Historic District Commission MEETING AGENDA

Monday, June 10, 2024 - 6:00 PM
Council Chambers, Easton Town Office
14 S Harrison Street

Historic District Commission Staff Report

Property Address: 4 N Washington Street

Figure 1

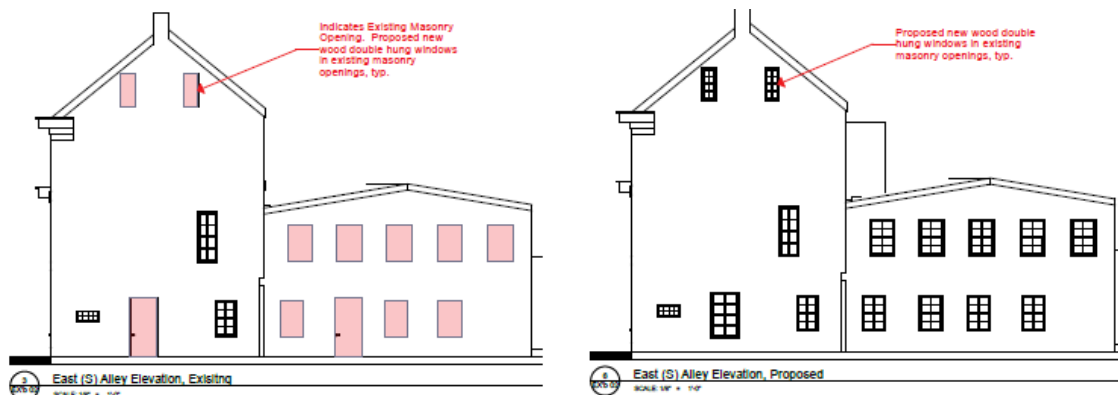
Staff notes that it is unclear what style of windows are being proposed. The original plans approved by the HDC in May of 2023 utilized 4/4 windows with SDL. The existing windows fronting Dover Street are also 4/4.

3 SOUTH ELEVATION EXISTING
RD2.1
1/4" = 1'-0"

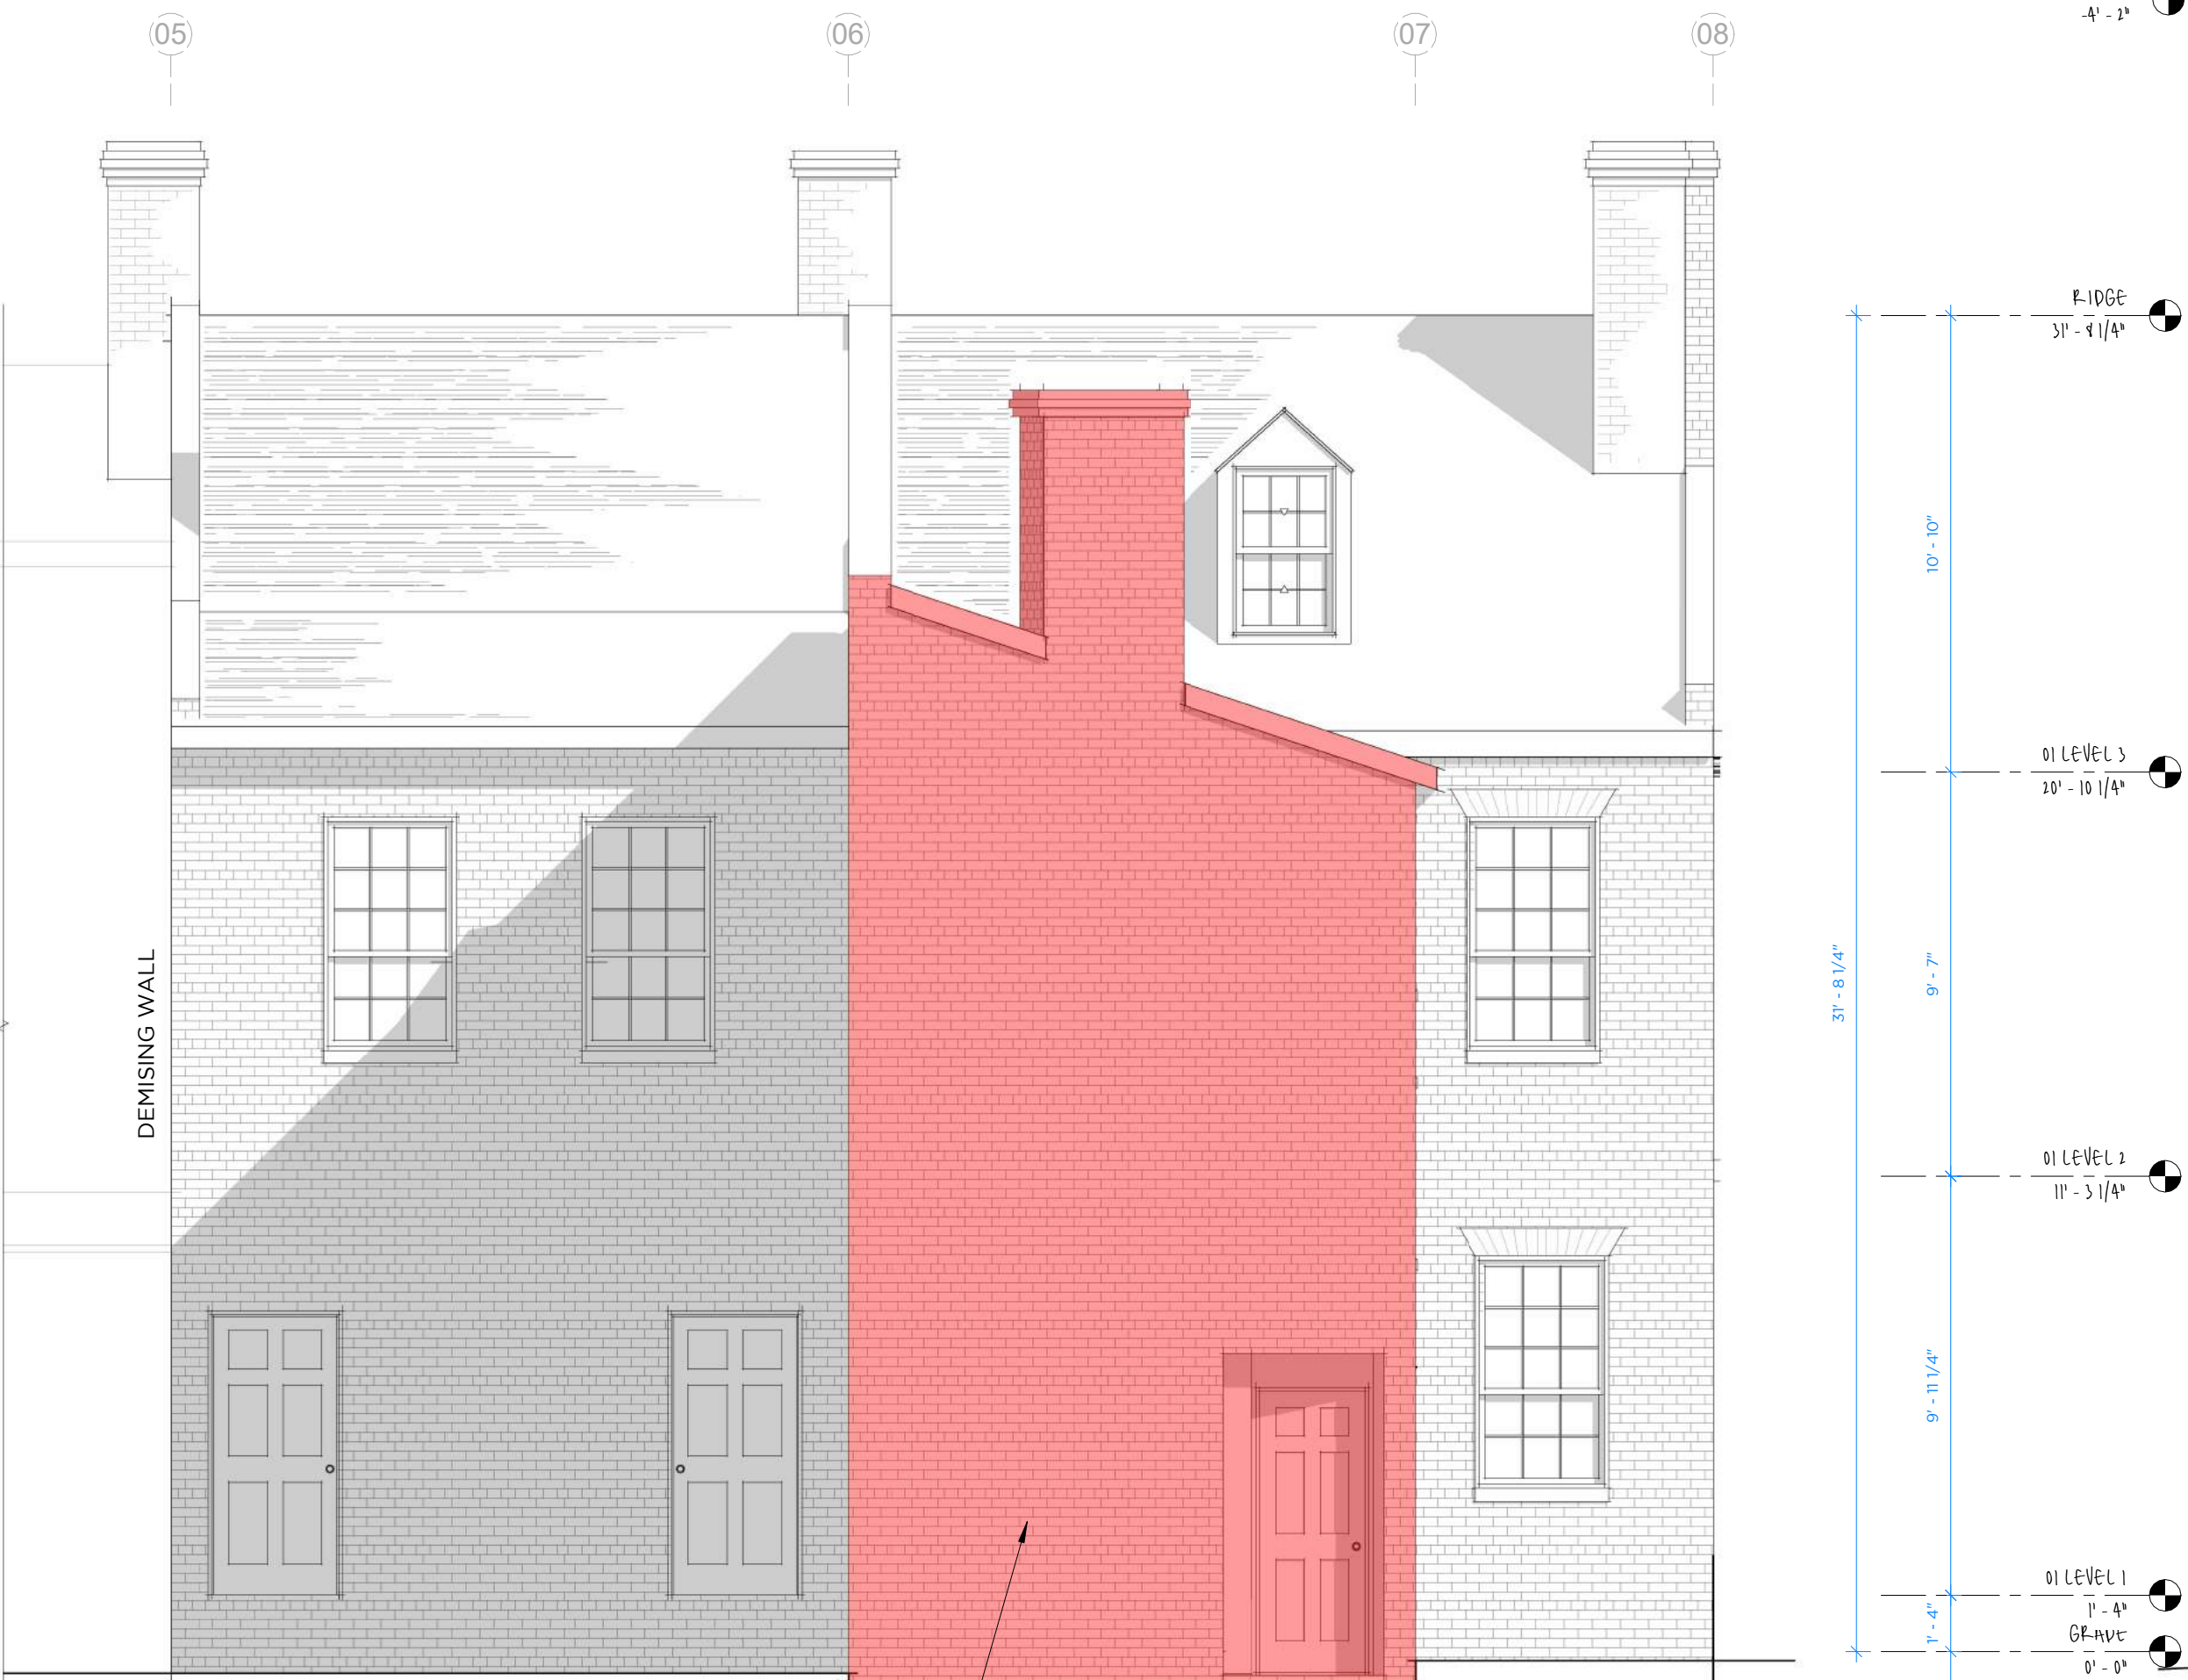
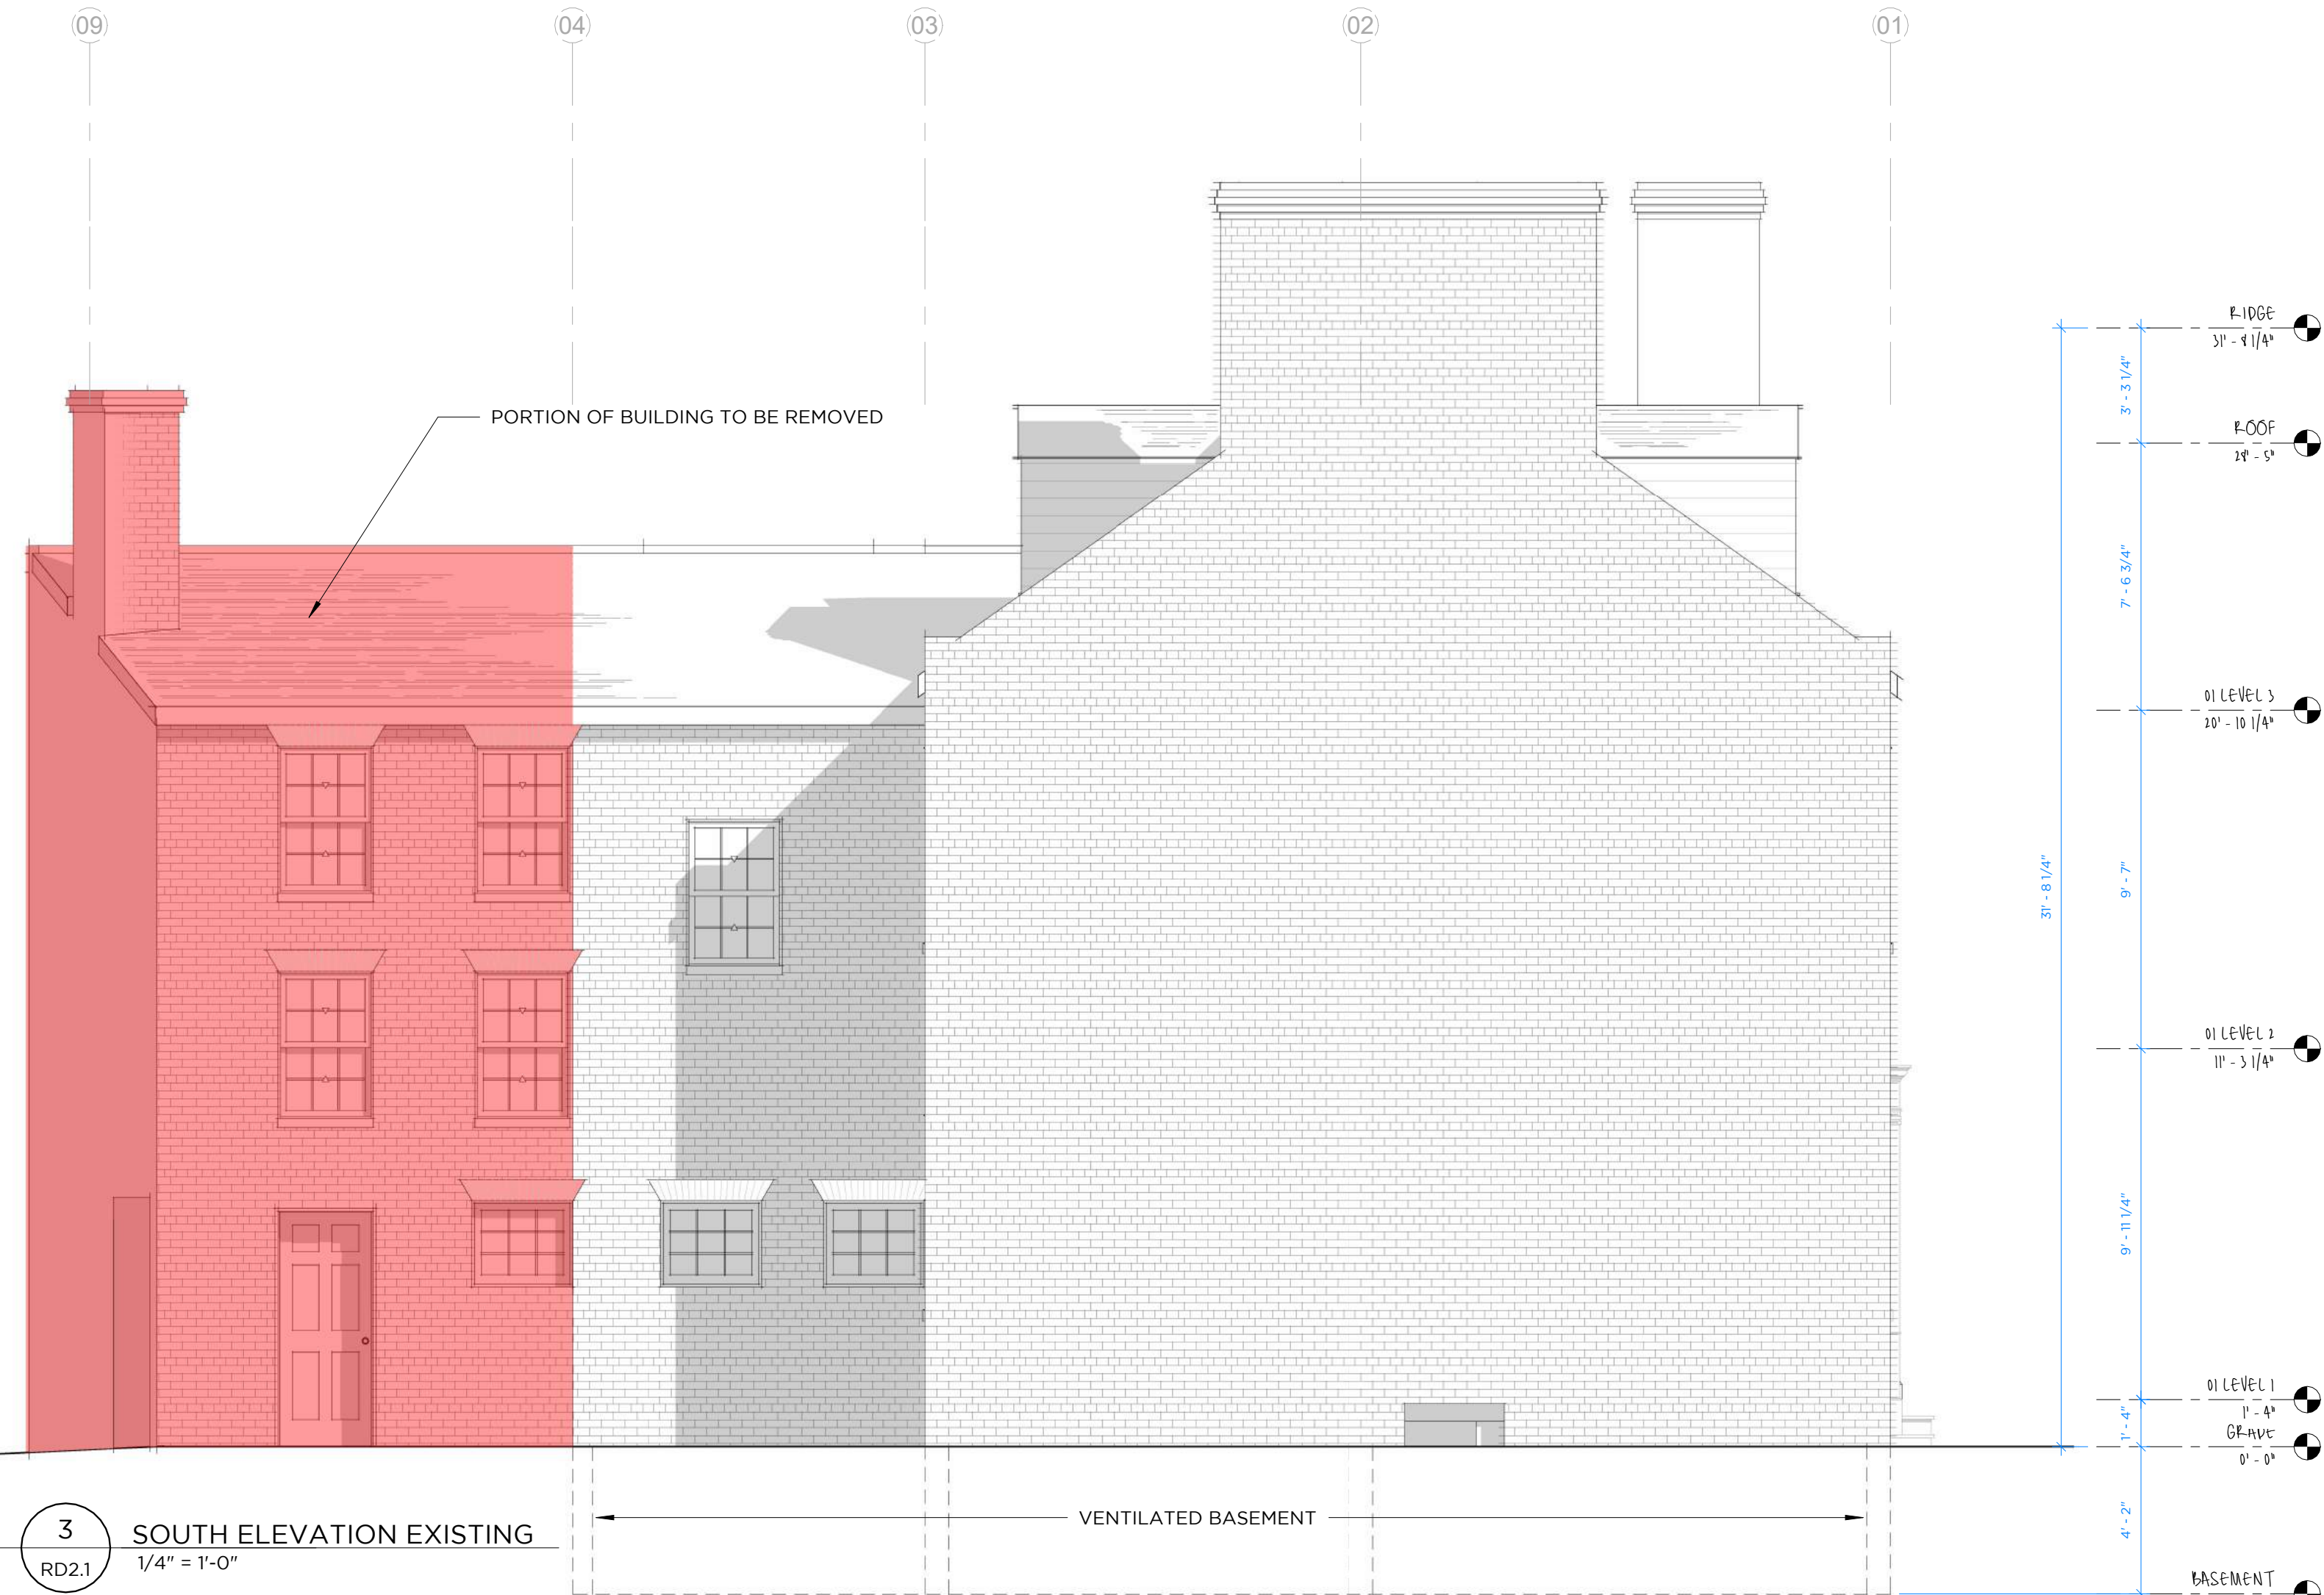
On April 8th, 2024 the Commission reviewed this same proposal to demolish a 180 square foot portion of the rear ell and construct a new two-story rear addition. At that meeting, the Commission found that the rear ell is a contributing structure and requested comments from the Maryland Historic Trust (MHT) on the appropriateness of the demolition of the contributing structure. On May 20th 2024, Planning and Zoning received comments from the MHT regarding the effect of the proposed changes to the building and its contributing status to the historic district.

1. The MHT's comment letter suggests that the proposed rear addition conflicts Standard 9 of the Secretary of the Interior's *Standards for Rehabilitation*. The MHT recommends that the new addition be "compatible in size and scale so as to not affect the building's National Register Status.
